**PROJECT**  
**BELLWAY HOMES**

**KINGSMERE KM7 - KM9 BICESTER, OXFORDSHIRE**

**DRAWING TITLE**  
**LANDSCAPE DETAILS SHEET FOUR OF FOUR**

Drawing No.  
MCA1412-04 G

**SHEET FOUR**

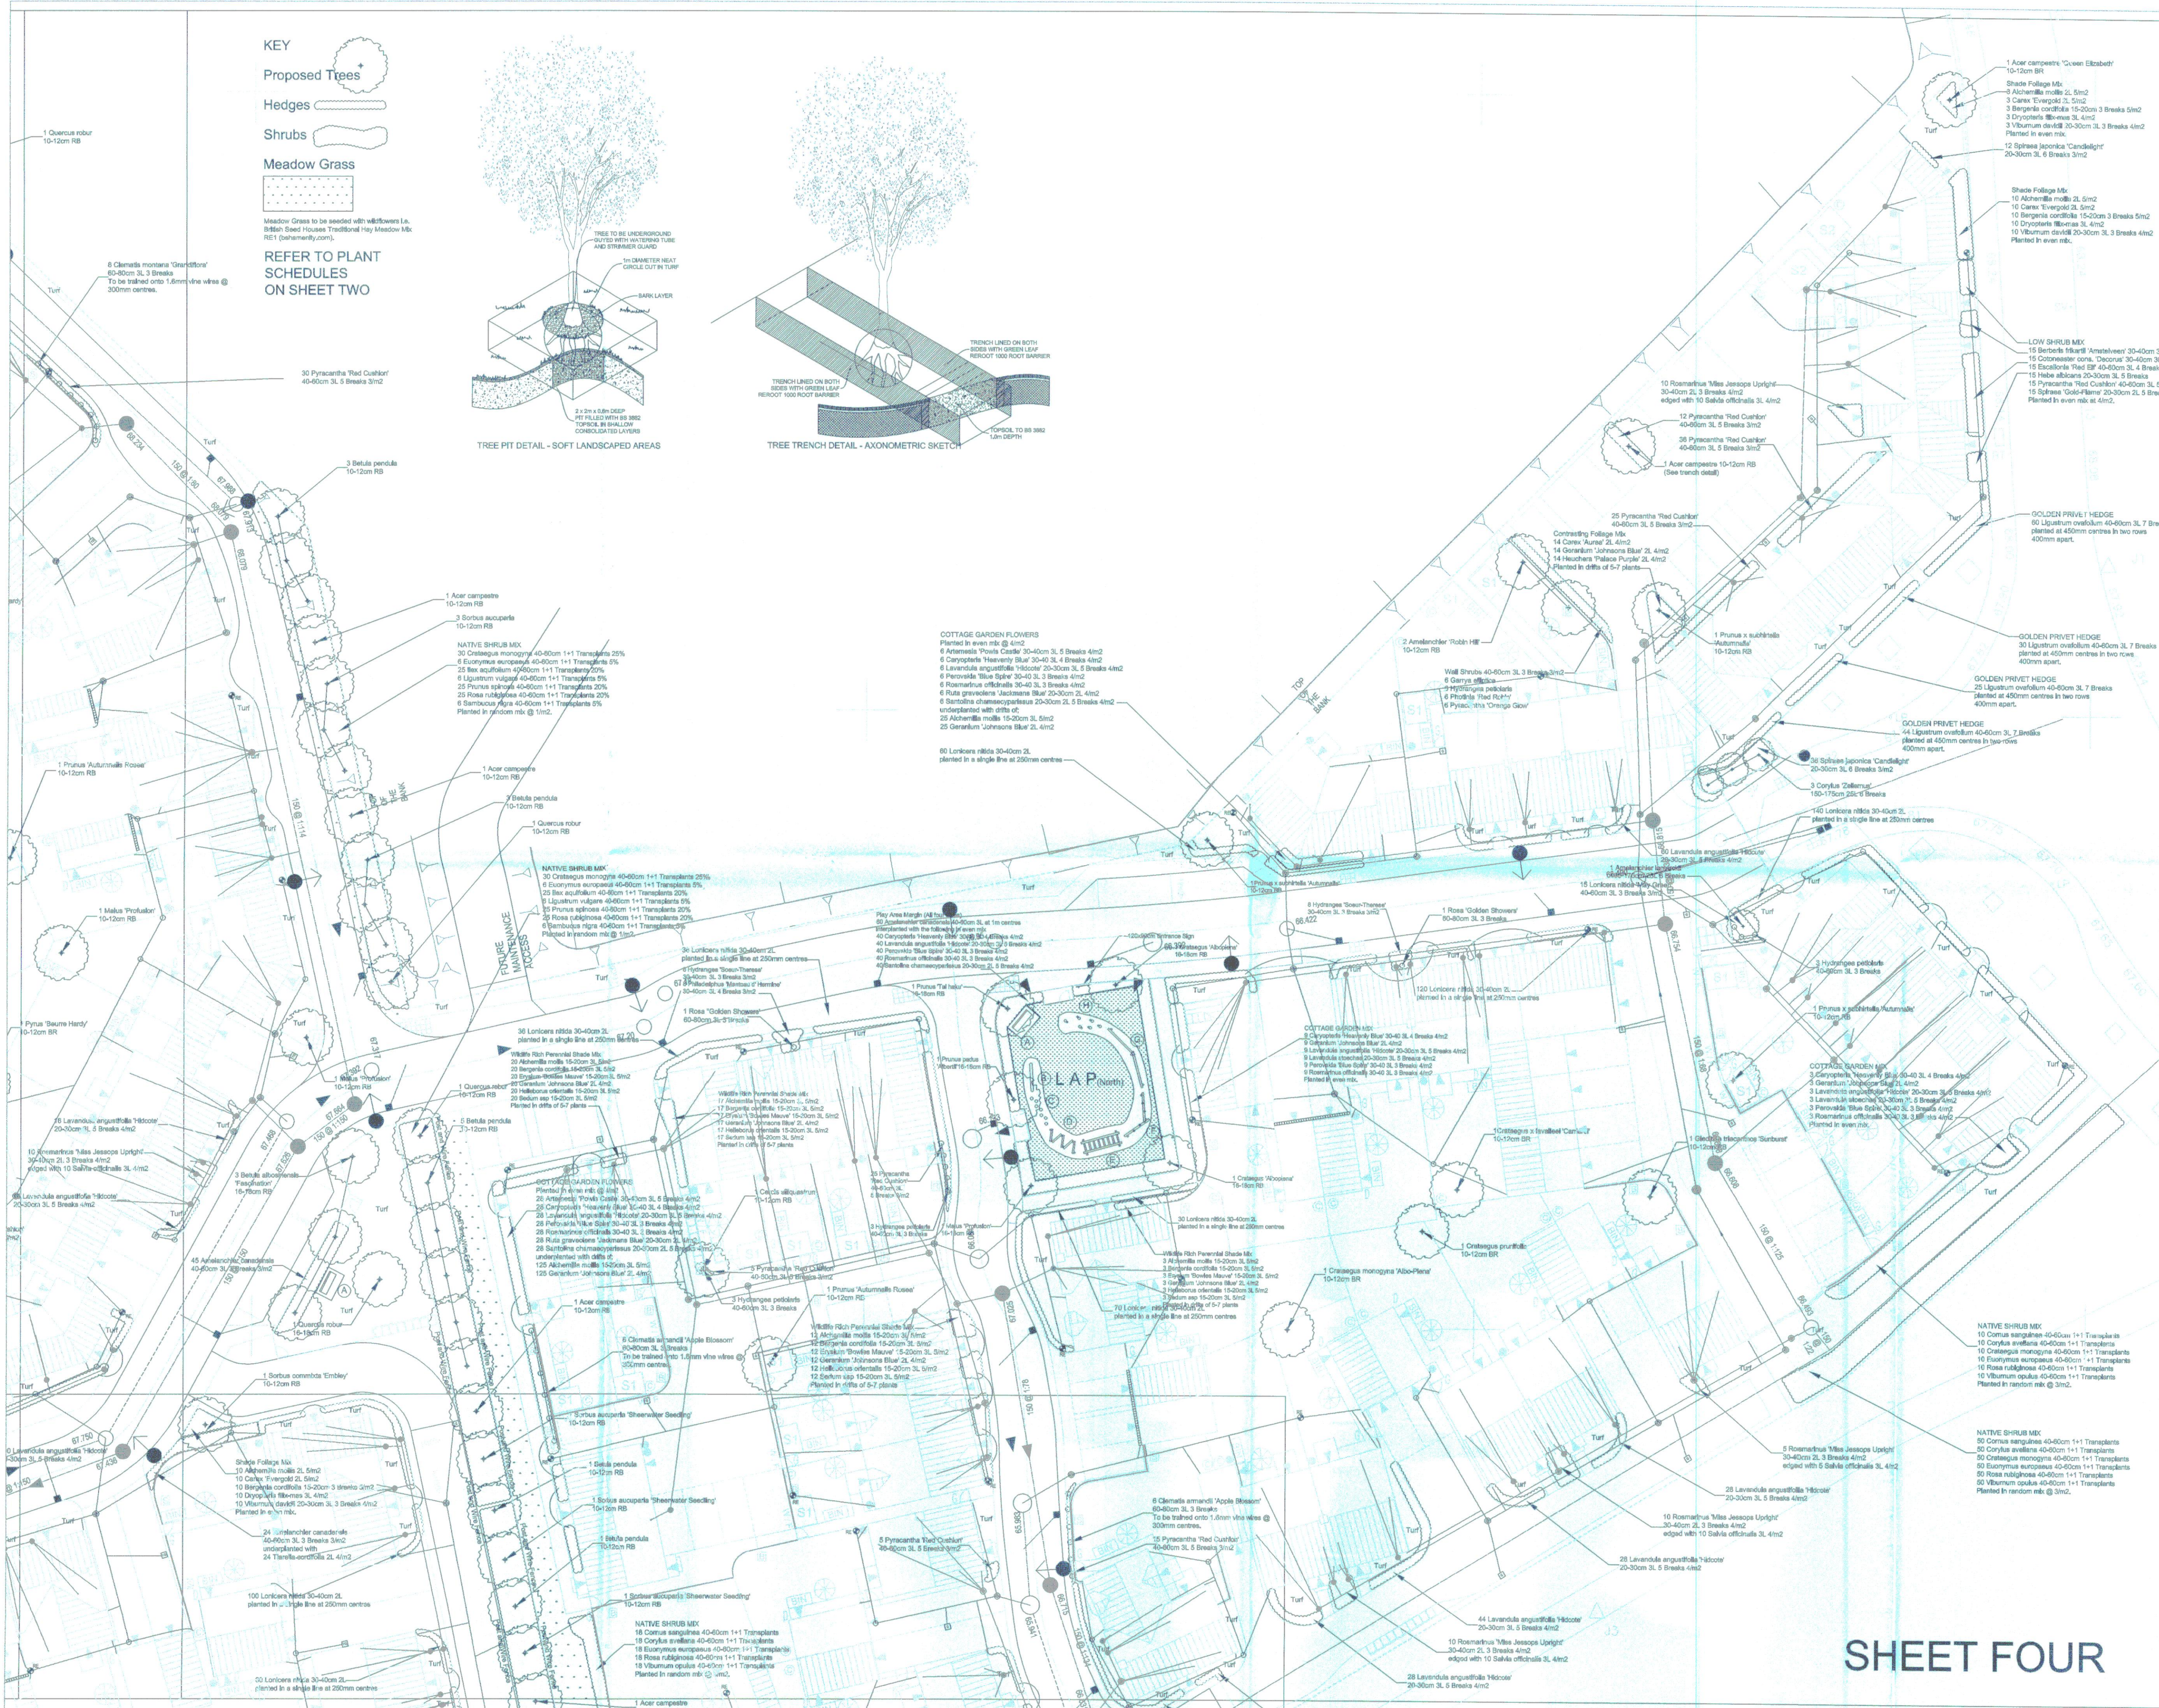
- Rev A 18-01-13**  
Mahaan Cooper Site Layout Plan AR 86234-101 Revision F incorporated and minor amendments made to planting to suit.
- Rev B 28-06-13**  
Mahaan Cooper Site Layout Plan AR 86234-101 Revision L incorporated and amendments made to planting to suit.

- Rev C 08-09-13**  
Drainage layout incorporated and planting adjusted to suit.  
Tree pit details added.
- Rev D 30-09-13**  
Trees around underground water storage tanks moved to edges of apses.

- Rev E 08-10-13**  
LAP furniture and equipment indicated.  
Amendments required by Linda Griffiths/CDC 07-10-13 and add-on:  
1) Native hedge along the eastern school boundary replaced with turf to avoid excessive maintenance along.

2) Habitat Links  
Meadow grass sowing.  
Species mix of understorey altered to include Hawthorn, Blackthorn and Holly, Guelder Rose and Dogwood defined. (Hawthorn is HIGH WATER DEMAND).  
Trees altered to reflect comments:  
Oak is too large for this area (NRBC Guidelines) but has been indicated where recommended.  
Trees rearranged to create more consistent habitat link.  
Post and Wire Fencing added.

3) Foyer Lobby boundary hedge deleted as recommended.  
4) Native Box hedge changed to non-native Loraine Hibbs.  
5) Variable access to Foyer Lobby will be prevented.

6) LAP trees altered as specified.  
7) Trees adjacent plots 9 and 20 altered as recommended.  
8) Prunus across site and adjacent to heavy trees and have not been altered.

9) Felling of holl is not a nuisance and Mahaan Cooper has been retained.  
10) Field Maple is much too large to plant and to plant 30 and Prunus has been retained.

11) Tree pit specifications will be described in the landscape specification.
- Rev F: 25-11-13 MC**  
Tim Brown's comments (04/11/13) and MCA add-on:  
LAP opposite plots 63 & 64 -  
Available space modified by deletion of planted bed including Ruta graveolens which can cause skin blisters.  
Oak tree is the focus of this village green and its removal from the scheme is related as this is one of the very few positions that an English native tree of scale can be accommodated.  
LAP is a simple grass area as agreed previously.

- LANDSCAPING**  
South-eastern school boundary hedged with Hornbeam and a grass margin.  
Planting adjacent plot 15 deleted on earlier revision.  
Tree sizes have been amended to include 40-20-30cm girth. Unlike opposite plots 65-70, 16-18cm girth trees to streets, LAP, PCG & Habitat Link.  
Tree pit details indicated.

- LAPS**  
Additional play equipment has been added to the northern and southern LAPS.
- PLANT SCHEDULES**  
The plan is annotated with full details of plant sizes, densities and stock type. Full numeric schedules are on sheet two.  
Jon Brown's comments (20/11/13) and MCA add-on:  
Tree species comprehensively altered in full accordance with Mr Brown's recommendations.  
Habitat Corridors - All altered in full accordance with Mr Brown's recommendations.

- Rev G: 12-05-14 MC**  
Current engineering layout updated and landscape scheme adjusted to suit.  
North and South LAPS updated to LPA requirements.
